PACIFIC GAS AND ELECTRIC COMPAN 245 Market Street RICHARD H. PETERBON San Francisco 6 PREDERICK T. BEARLS SUtter 1-4211 January 25, 1963 AIR MAIL Mr. Eber R. Price, Assistant Director Division of Licensing and Regulation U. S. Atomic Energy Commission Washington 25, D. C. Re: Indemnity Agreement No. B-21 Dear Mr. Price: The above-numbered indemnity agreement, which covers Unit No. 3 of our Humboldt Bay Power Plant, includes a map which outlines the location of the indemnified facility in red. Certain changes in the location of the fence separating Unit No. 3 from the remainder of our Humboldt Plant have been

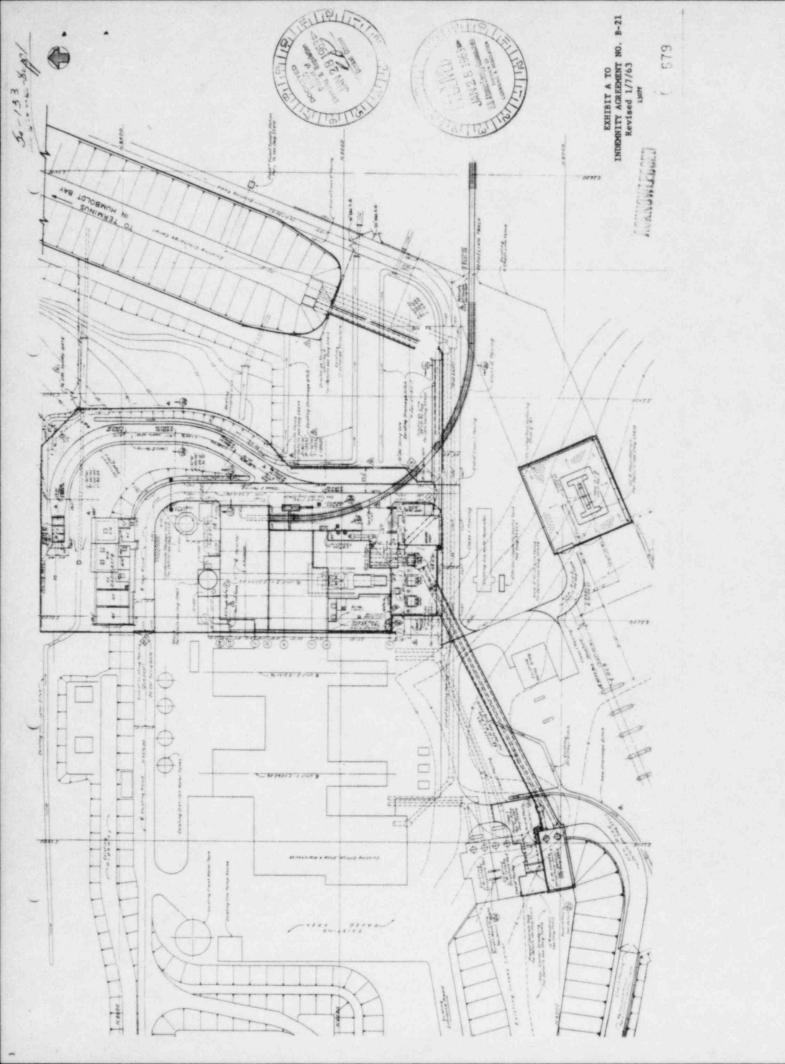
made since the agreement was signed. The map has been revised to reflect these changes, and I enclose 12 copies of the new map for attachment to your copies of the above-numbered agreement. The map presently attached to the agreement should be removed and destroyed.
